Amendments to the Claims:

Attachment: Replacement Sheets
Annotated Sheets Showing Changes

FIG. 1
PRIOR ART

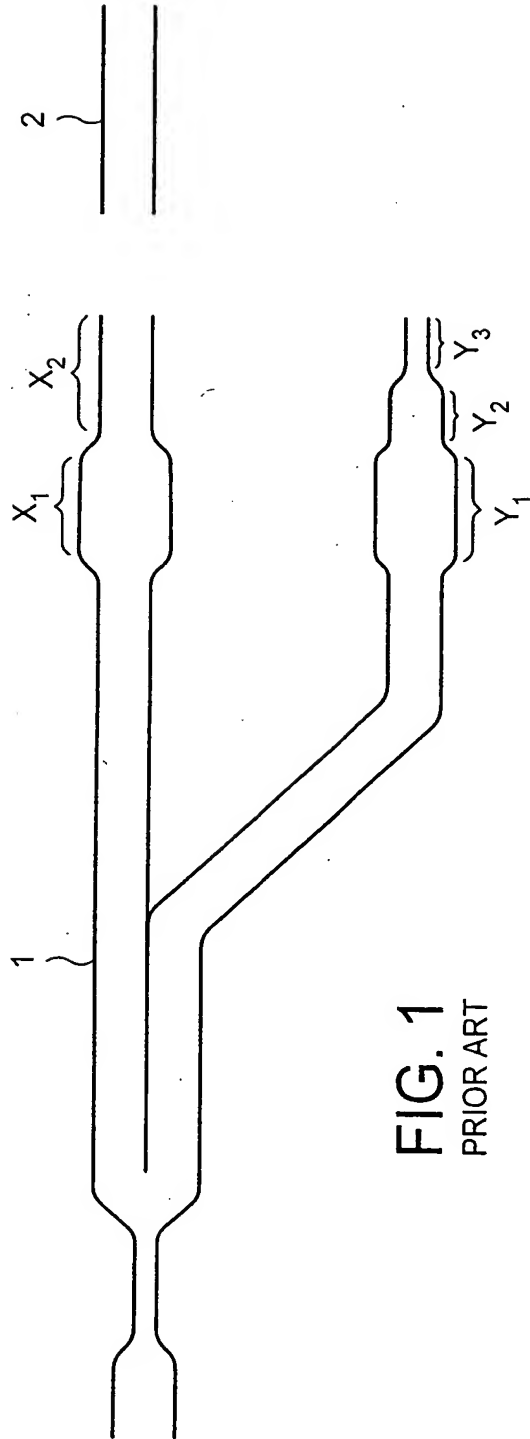
The attached sheets of drawings includes changes in Figs. 1-3. These sheets, which includes Figs. 1-3, replaces the original sheets including Figs. 1-3. In Figs. 1-3, the illustrated diameter of pipe 2 has been reduced.
